Providence City Plan Commission

April 24, 2012

AGENDA ITEM 7 ■ 257 THAYER STREET

OWNER/APPLICANT: Gilbane Development Company	PROJECT DESCRIPTION: Construction of a mixed use apartment building with 102 units geared toward student housing with retail on the first floor, underground parking and an interior courtyard.
CASE NO./PROJECT TYPE: 12-011 MA Master Plan Approval	
PROJECT LOCATION: 257 Thayer Street	RECOMMENDATION: Approval of the Master Plan subject to the findings and conditions noted below.
NEIGHBORHOOD: College Hill	PROJECT PLANNER: Robert Azar and Choyon Manjrekar

A rendering of the proposed building

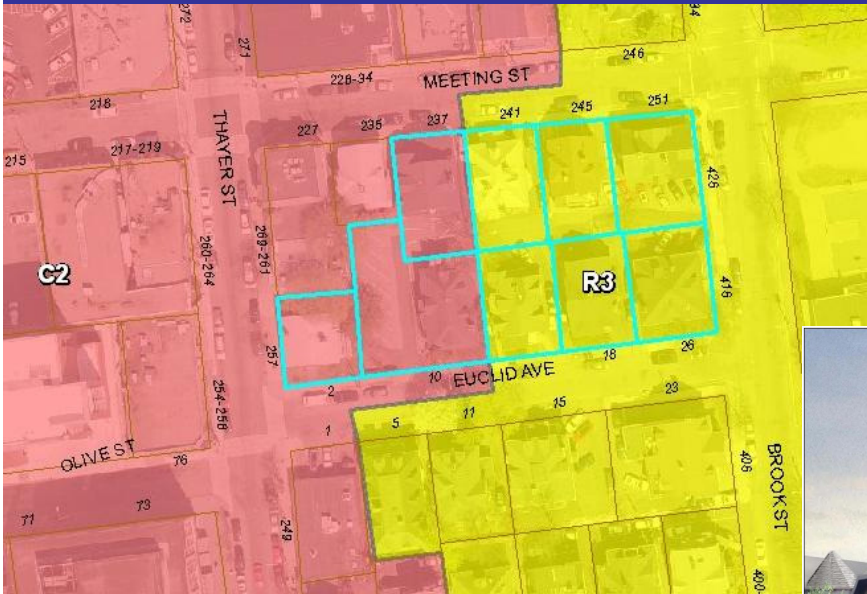
- It is unclear where proposed retail will be located. It should be located fronting on Thayer St.
- The building presents areas of visible blank walls adjacent to neighboring buildings. This is a concern that should be addressed through building design.

- The proposed development is considerably larger, but not necessarily taller than other developments east of Thayer St. The massing of the building is more characteristic of institutional buildings to the west of Thayer St. and to the east of Brook St., within the Brown and Wheeler School campuses. The building's design should minimize the impact of this massing. The building should also be an example of outstanding architecture, and in no way seem generic.

1. The applicant shall present a utility and stormwater management plan at the preliminary plan stage.
2. The applicant shall conduct a study detailing the impacts of traffic generated by the project.
3. The applicant shall prepare an assessment of the impact to the built environment through a survey of the existing structures on site.
4. The design of the building shall be refined to respond architecturally to its surroundings and to address concerns of the impact of its large massing on the area.
5. The Commission shall conduct a public hearing on the comprehensive plan change and make recommendations to the City Council on the proposed comprehensive plan and zoning changes. Should the plan and zoning changes fail to be approved as proposed, the plan shall be modified accordingly.
